Figure 4.6.1 Proposed pedestrian connections at the north end of the site

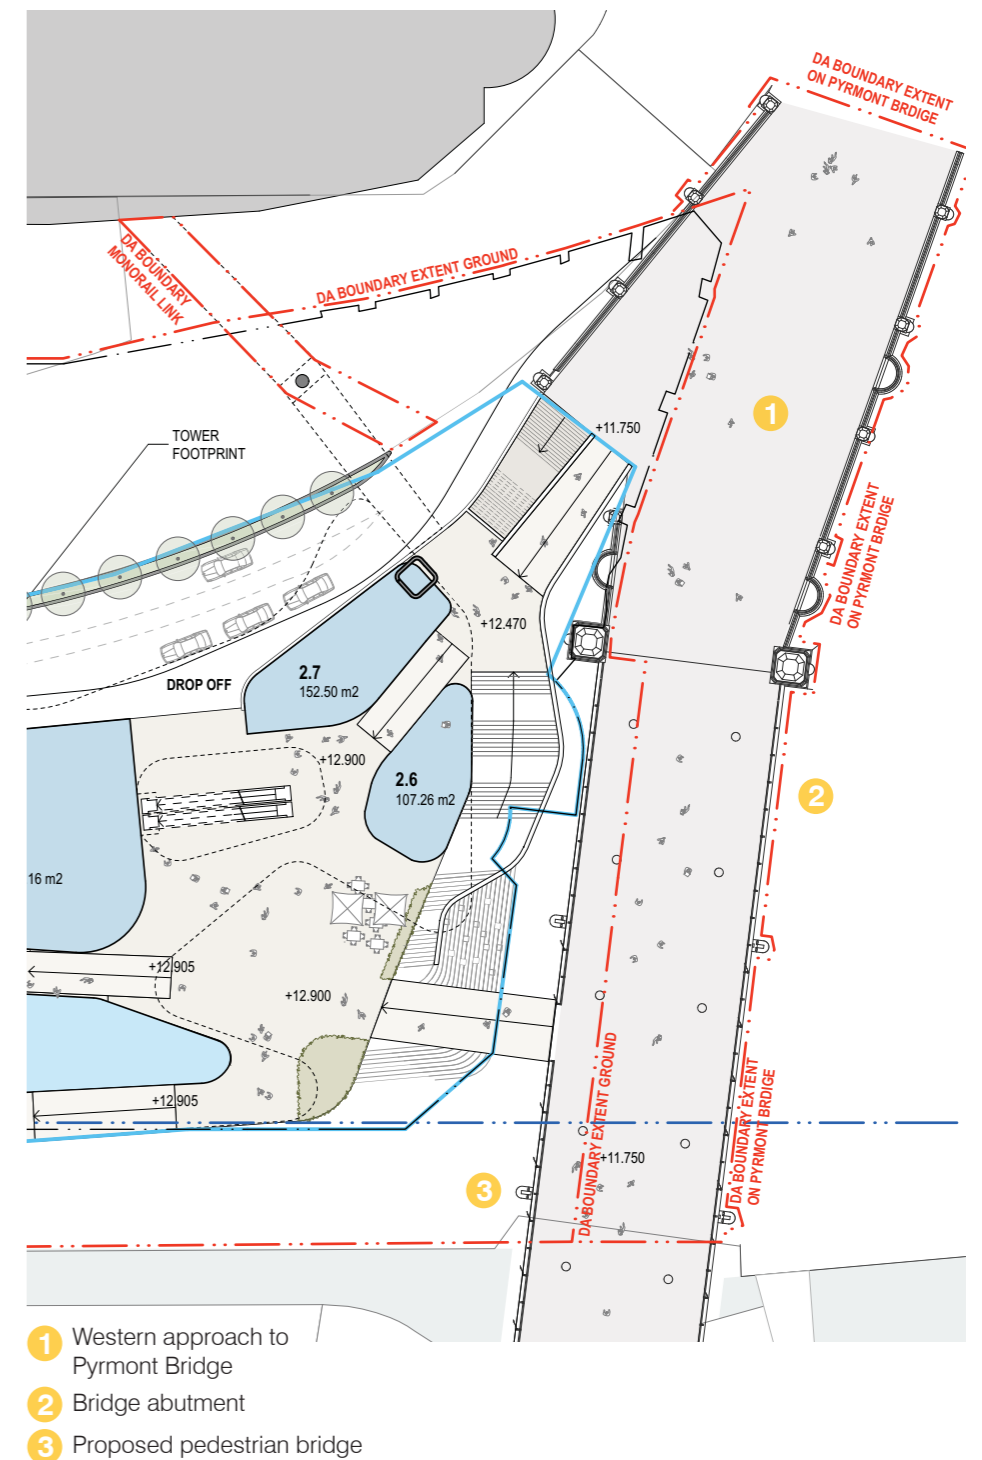
In addition to maintaining current entry points to the podium from the western approach to Pymont Bridge and the area at waterfront promenade level at the western bridge abutment, a new connection directly from the bridge deck into Level 2 is proposed (Figure 4.6.1). Heritage issues are considered manageable and it is noted that the bridge parapets are not original (refer Heritage consultant's report).

Figure 4.6.2 Entry to podium at south end of site (ground floor)

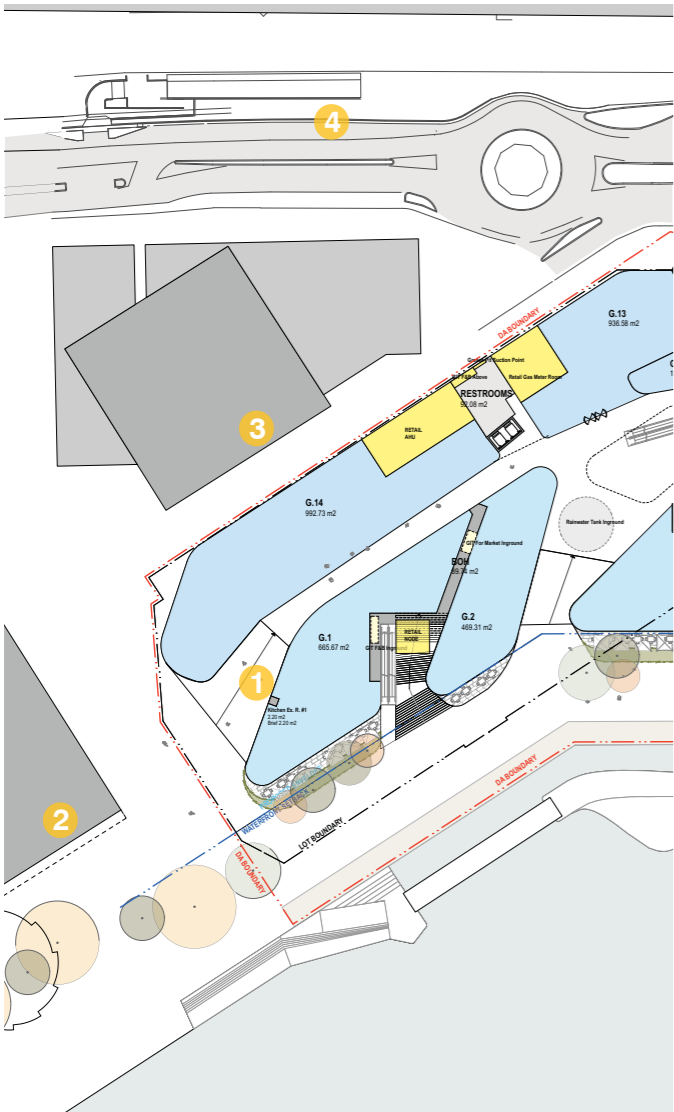
The new ICC includes a generous and well-designed pedestrian connection running between the Convention Centre and hotel, from the waterfront to Darling Drive and the Convention light rail stop. The proposed entry to Harbourside will help activate this link and provide an attractive and direct path from the proposal to the Inner West light rail service (illustrated in Figure 4.6.2).

Figure 4.6.3 Pedestrian bridges at north end of site (Level 3)

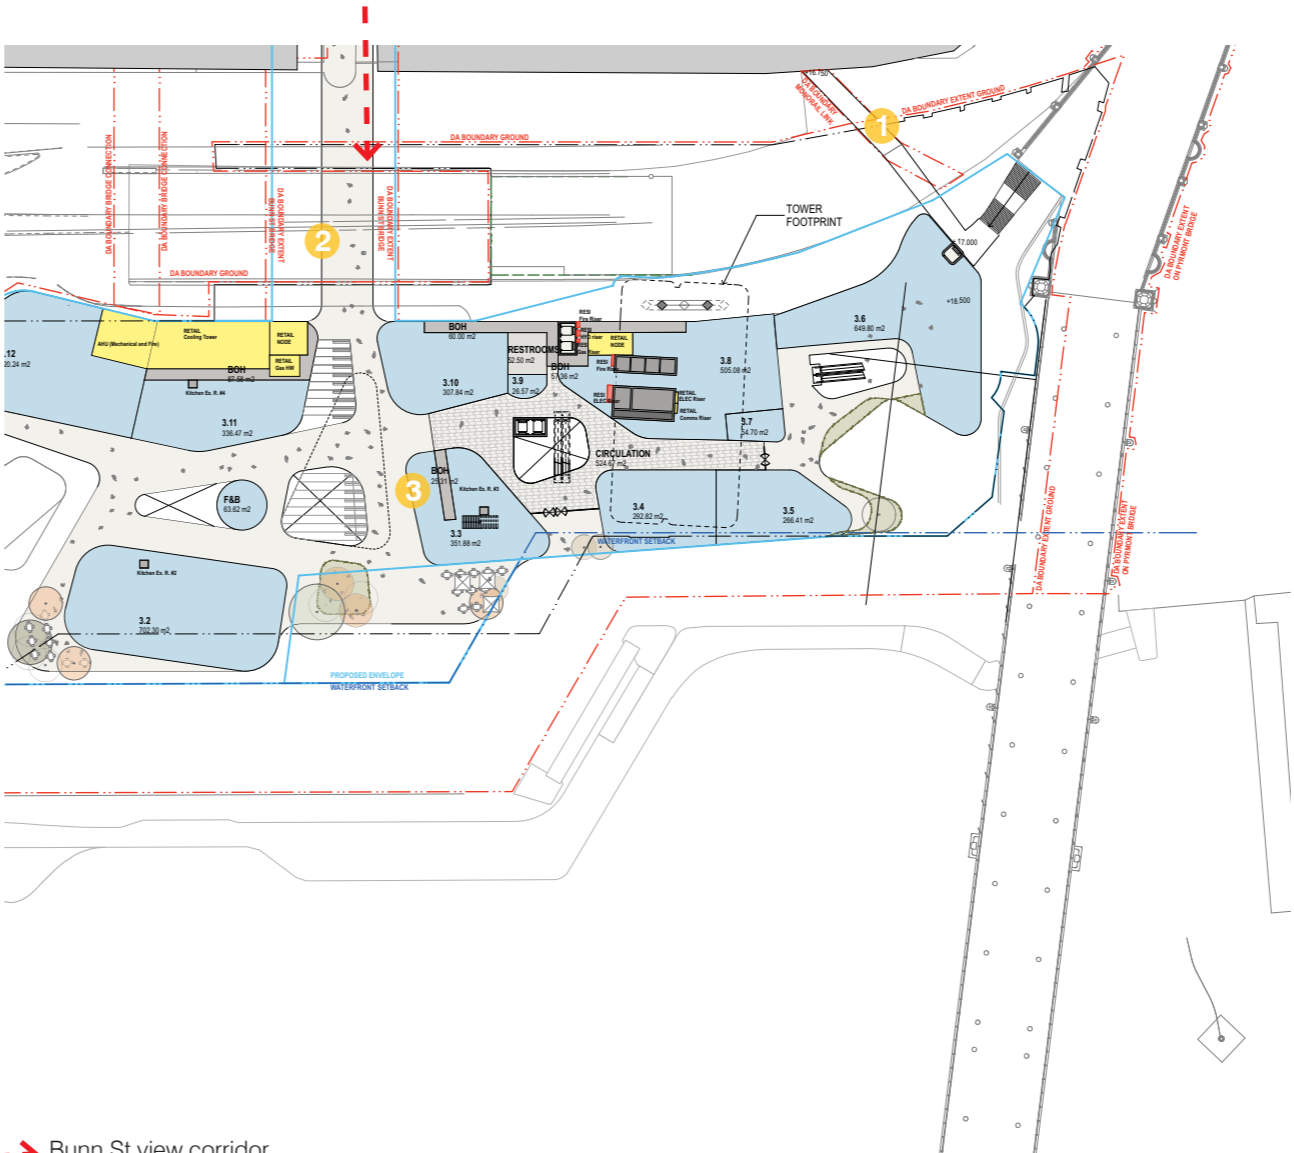
The existing pedestrian bridge which provided access to the former Monorail, and continues to serve Harbourside and Pymont Bridge, is to be retained and integrated into the new building (Figure 4.6.3). A generous new link at the same level and on the alignment of Bunn Street is proposed. The existing bridge connecting Harbourside to the parking garage to the west of Darling Drive and the light rail corridor will be demolished, with pedestrian access to the new Harbourside via the new Bunn Street bridge.

Figure 4.7.1 Vehicle access at ground level

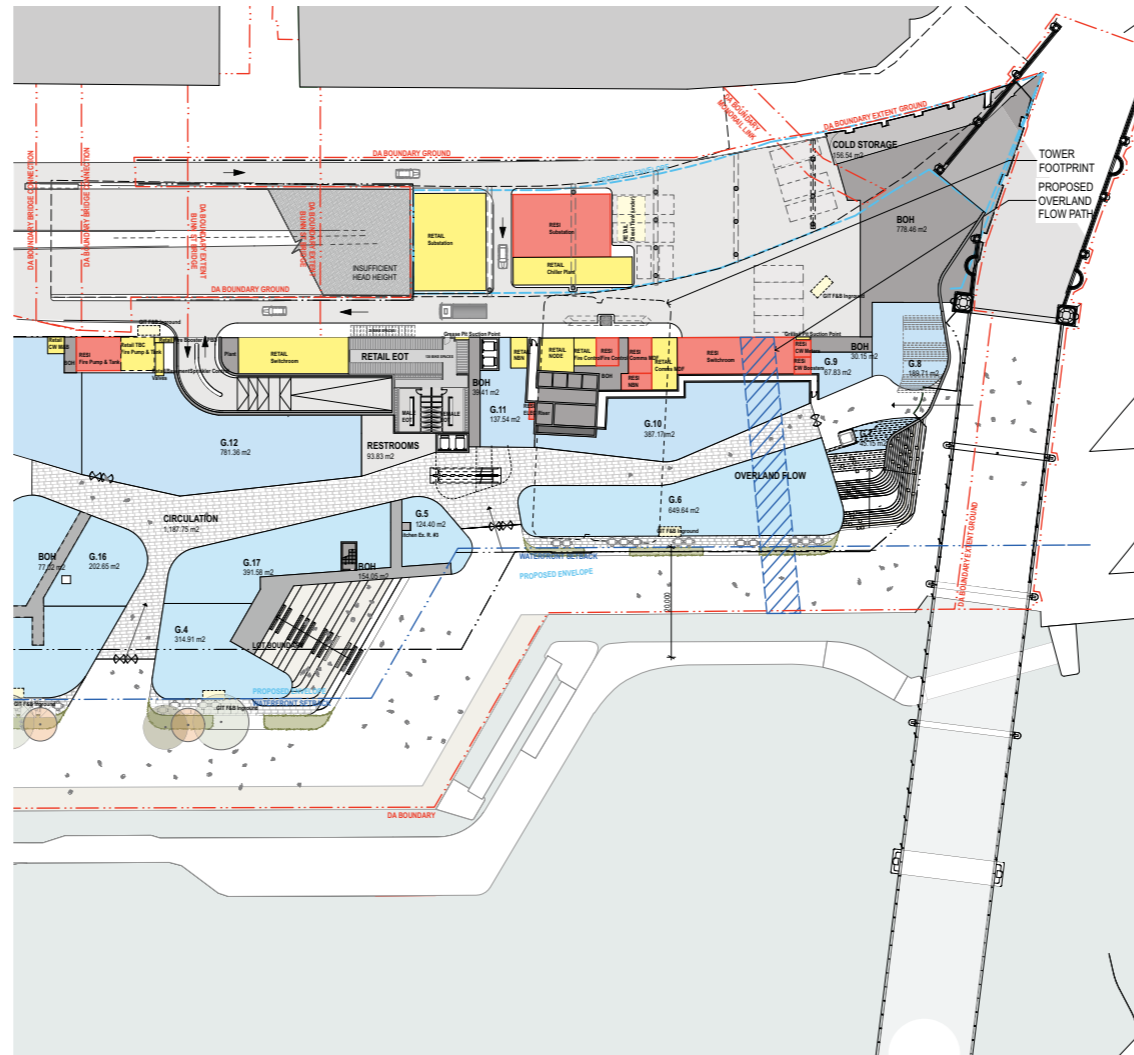
Vehicular access is limited to the western side of the site, off Darling Drive. The service road loop under the Darling Drive ramp will be upgraded. “Back of house” facilities will continue to be accessed from this road (Figure 4.7.1). Entry will also be provided to a ramp within the building which will feed the proposed basement loading and parking areas.

Figure 4.7.2 Vehicle access to residential lobby (level 1)

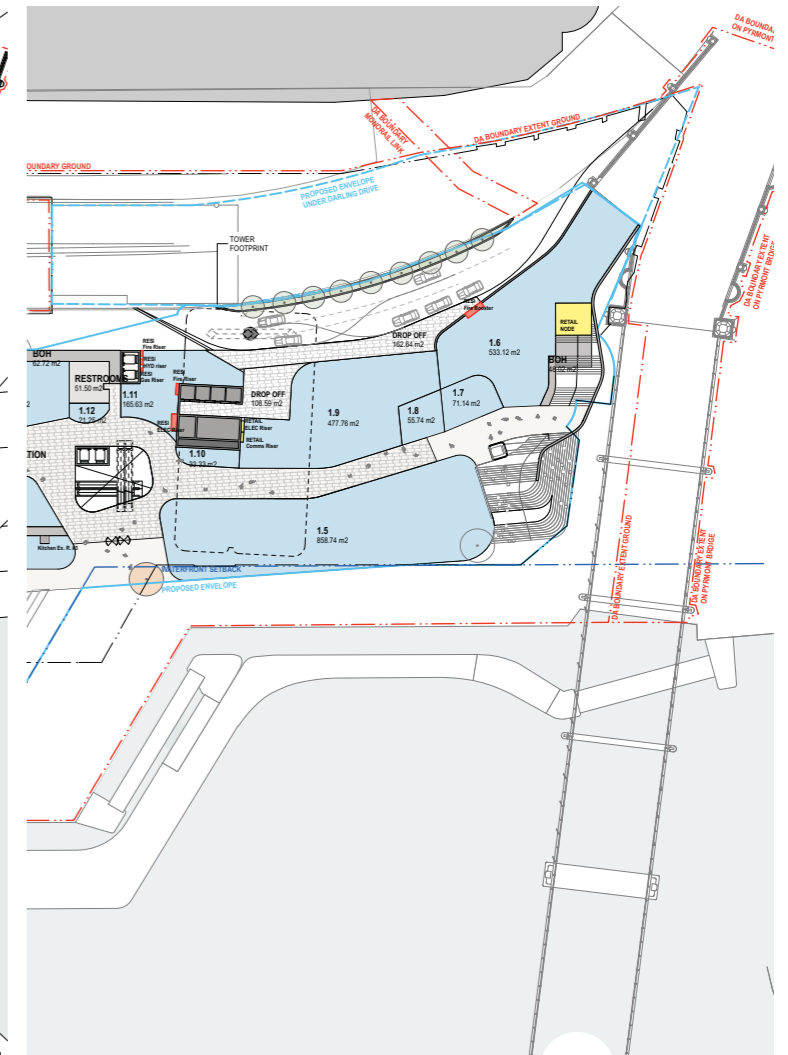
A new slip lane off the Darling Drive ramp and serving the residential tower lobby is shown at Level 1 (Figure 4.7.2). Road geometry and gradients will need further detailed analysis as part of subsequent DA submissions.

Architectus considers the proposed vehicular access to be an appropriate urban design response, subject to further detailed consideration and minimisation of impact at a detailed design stage.

Figure 4.8.1 Shadows cast by the proposal - June 21 (Midwinter)

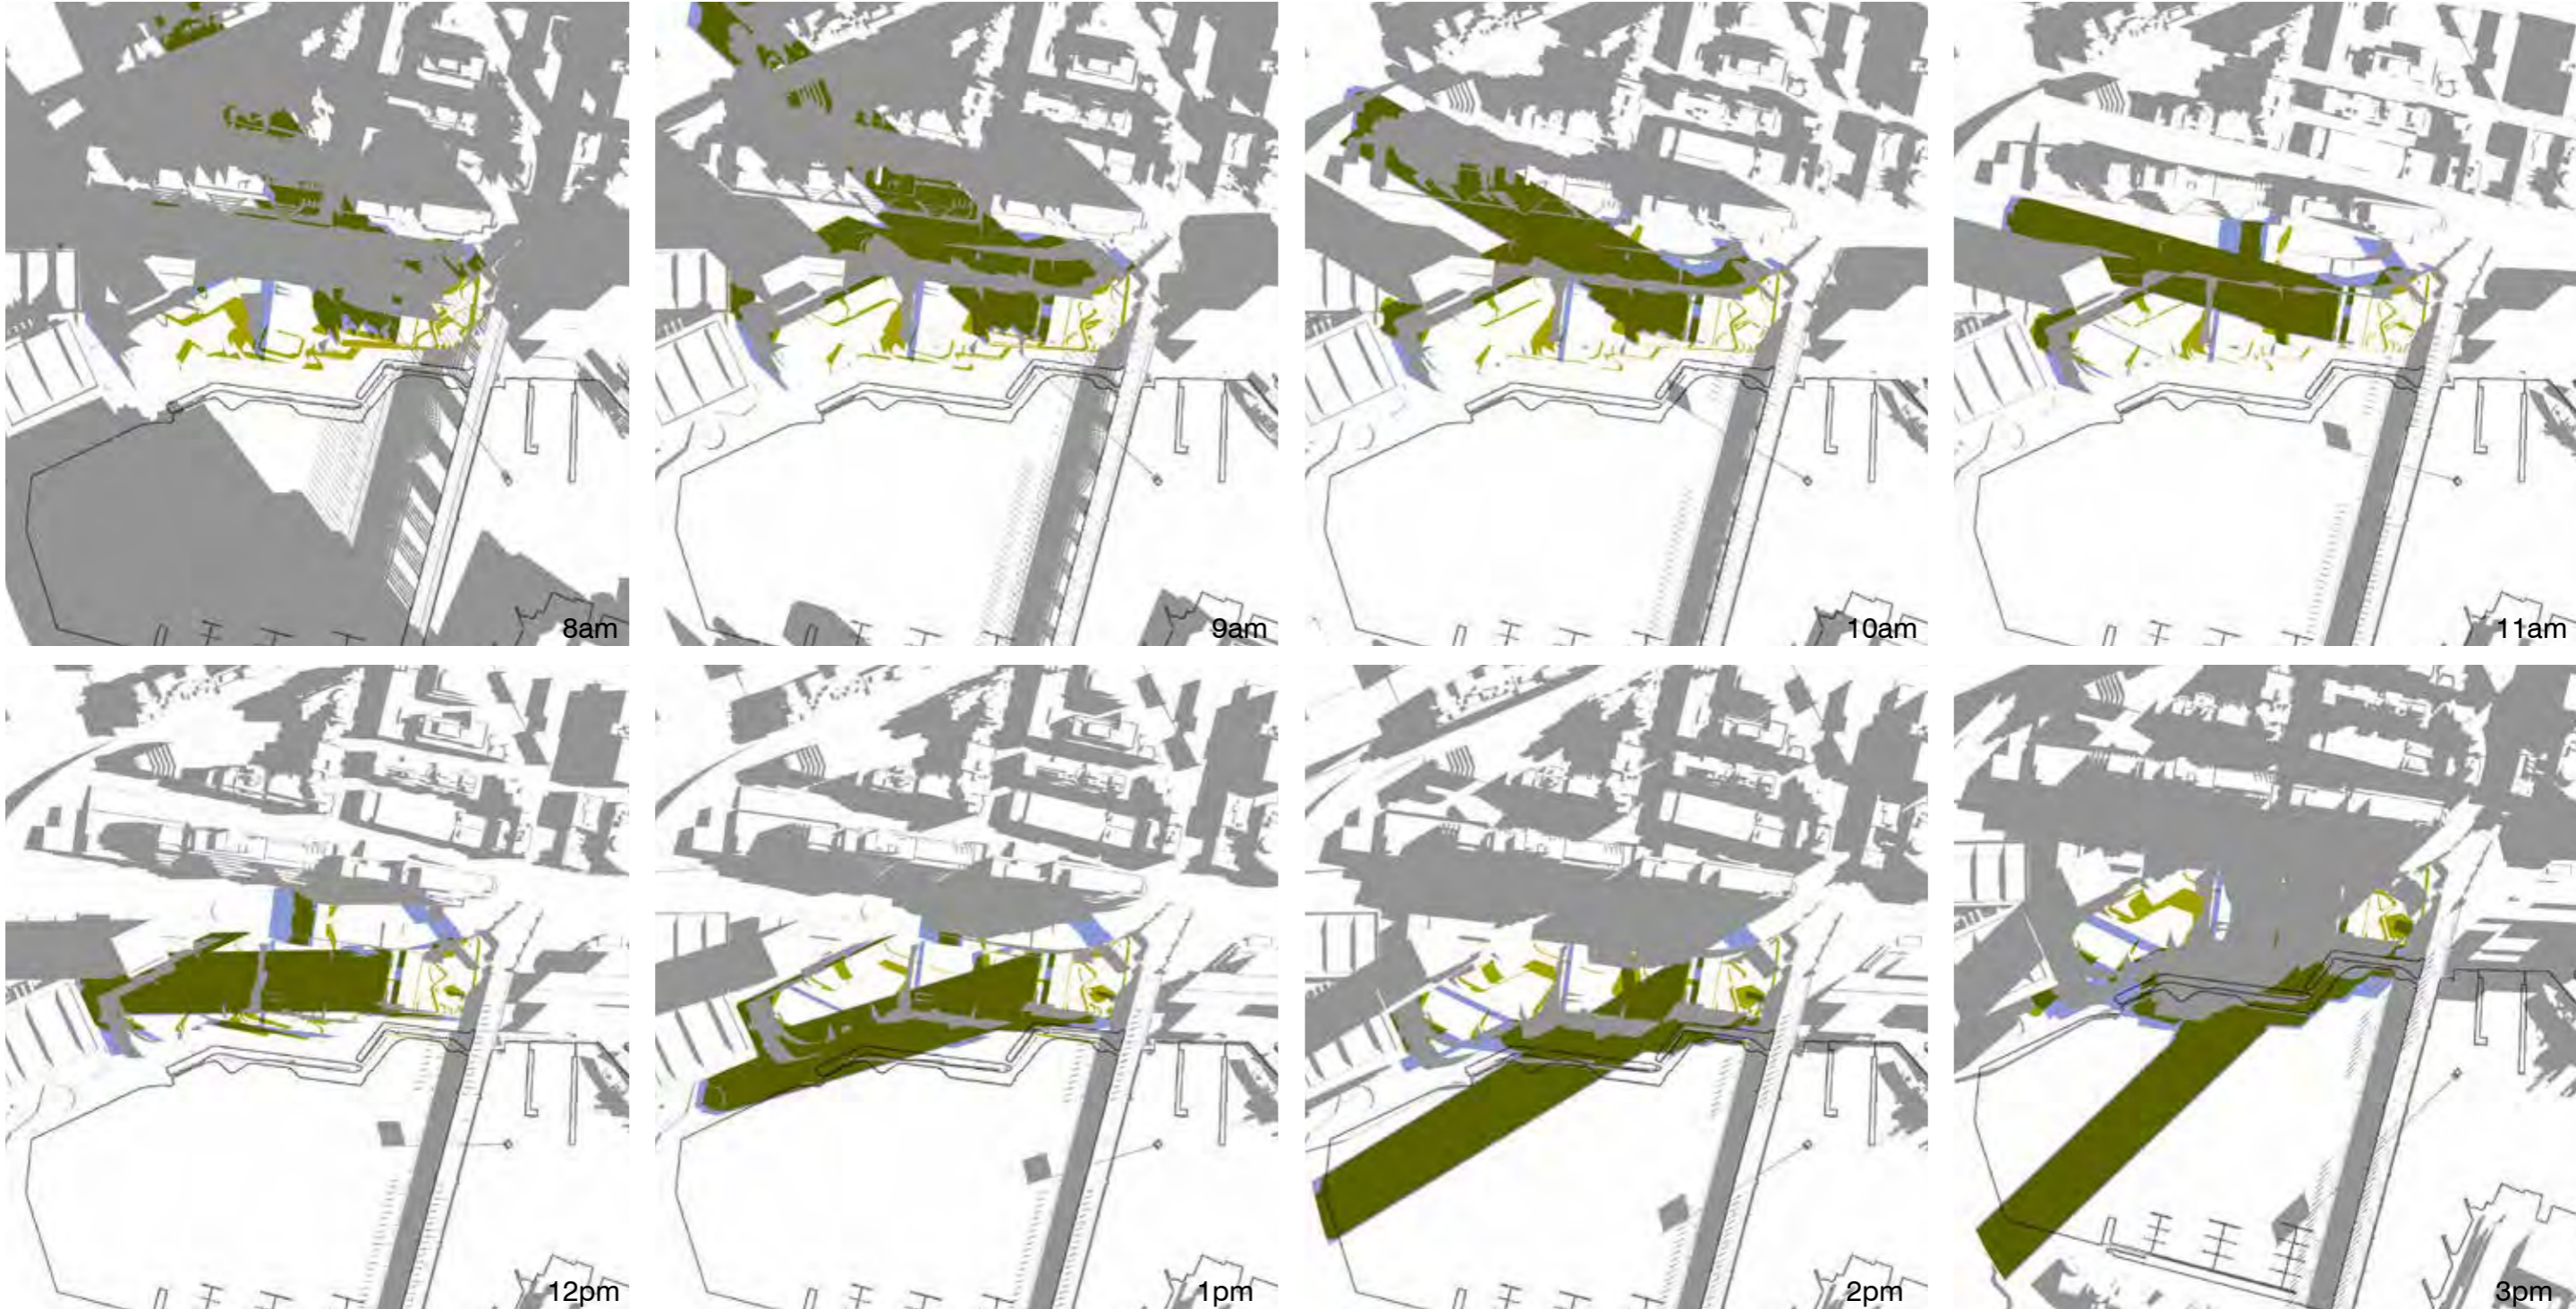
- 9.00am -- the waterfront promenade is fully sunlit, the podium casts shadows on Darling Drive and the tower overshadows part of the Novotel hotel and some existing Pyrmont buildings, mostly mixed-use and residential, beyond

- 10.00am -- the waterfront promenade remains fully sunlit, the podium continues to cast shadows on Darling Drive and the tower overshadows some existing Pyrmont buildings, mostly mixed-use and residential, beyond

- 11.00am -- the waterfront promenade remains fully sunlit, the podium casts negligible shadows on Darling Drive and the tower overshadows a small portion of the ICC hotel north façade

- Midday -- the waterfront promenade remains fully sunlit and the tower overshadows approximately one quarter of the ICC hotel north façade
- 1.00pm – shadows are cast mainly by the tower, with a significant area of the waterfront promenade in front of the proposal and ICC entry plaza in shadow, and a distance of approximately 160m metres along the waterfront between areas with good sunlight

- 2.00pm – the tower and podium shadows fall only on the promenade in front of the proposal, with approximately 70 metres along the waterfront between areas with good sunlight

- 3.00pm – the waterfront promenade is in shadow and the tower shadow reaches a small portion of the promenade in front of the IMAX theatre.

In summary, with the long dimension of the site running north-south and the tower located towards its northern end, the proposal is in significant part self-shadowing. The primary concern is impacts on the waterfront public realm. This is fully sunlit until midday and varying portions of it continue to receive direct sun until 2.00pm. The tower's shadow

Based on the above, Architectus considers that the shadow impacts of the proposal are acceptable.
